UNITED STATES
DEPARTMENT OF THE INTERIOR
BUREAU OF LAND MANAGEMENTFORM APPROVED
OMB NO. 1004-0135
Expires: July 31, 2010**SUNDRY NOTICES AND REPORTS ON WELLS**
*Do not use this form for proposals to drill or to re-enter an abandoned well. Use form 3160-3 (APD) for such proposals.***WELL CONSERVATION**
ARTESIA DISTRICT
OCT 11 2016
RECEIVED**SUBMIT IN TRIPLICATE - Other instructions on reverse side.**

5. Lease Serial No.
NMNM28172
6. If Indian, Allottee or Tribe Name
7. If Unit or CA/Agreement, Name and/or No.
8. Well Name and No.
ADRIANNE 6 FED 1
9. API Well No.
30-015-34319-00-S1
10. Field and Pool, or Exploratory
CHOSA DRAW-MORROW
11. County or Parish, and State
EDDY COUNTY, NM

Cimarex Respectfully requests approval to plugback the Morrow, Perforate and recompleat into the Cisco Canyon and Wolfcamp formations. Cimarex also proposes to downhole commingle production from the Cisco Canyon and Wolfcamp Zones. Please see attached recompleat procedure for your review and approval.

Production Operations – Carlsbad Region, Permian Basin
Adrianne 6 Federal #1 - Cisco Canyon and Wolfcamp (Ciscamp)
Proposed Commingling Allocation Factors. Eddy County, NM

Proposed WBD
KB - 16' above GL

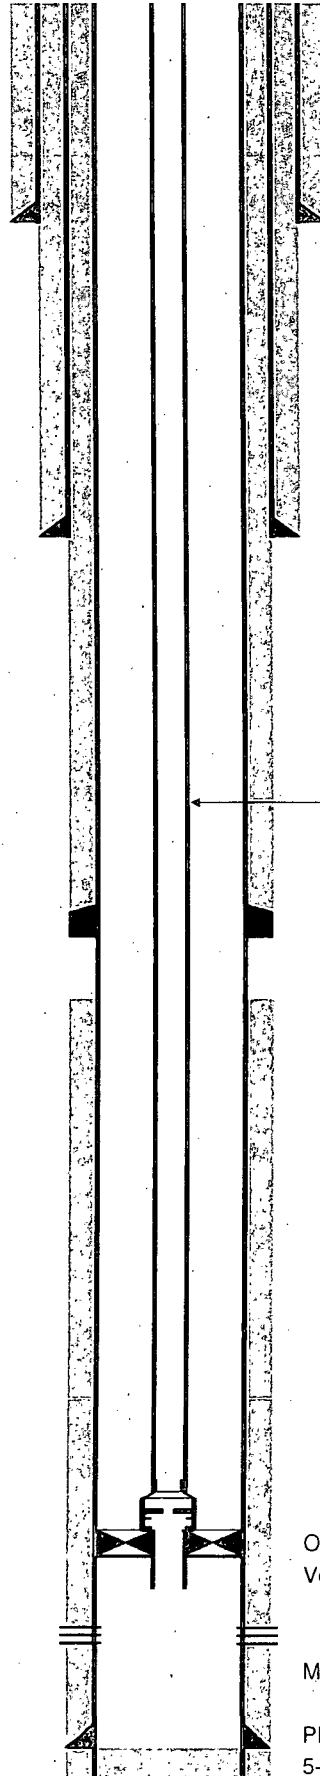
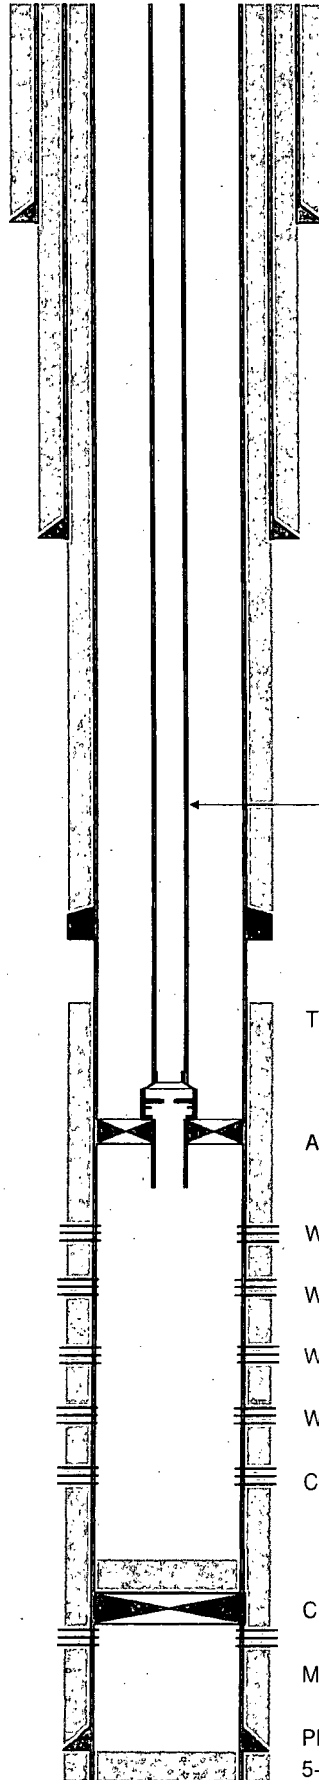
7. RIH w/ gauge ring/junk basket to +/- 11,286'
8. RIH w/ 5-1/2" CIBP and set at +/- 11,256'
9. RIH w/ ^{tubing} ~~baller~~ and ^{pump 25sx} ~~ball 35'~~ of cement on top of CIBP set at +/- 11,256'

In lieu of a cement plug across perforations in a cased hole (not for any other plugs), a bridge plug set within 50 feet to 100 feet above the perforations shall be capped with 25 sacks of cement.
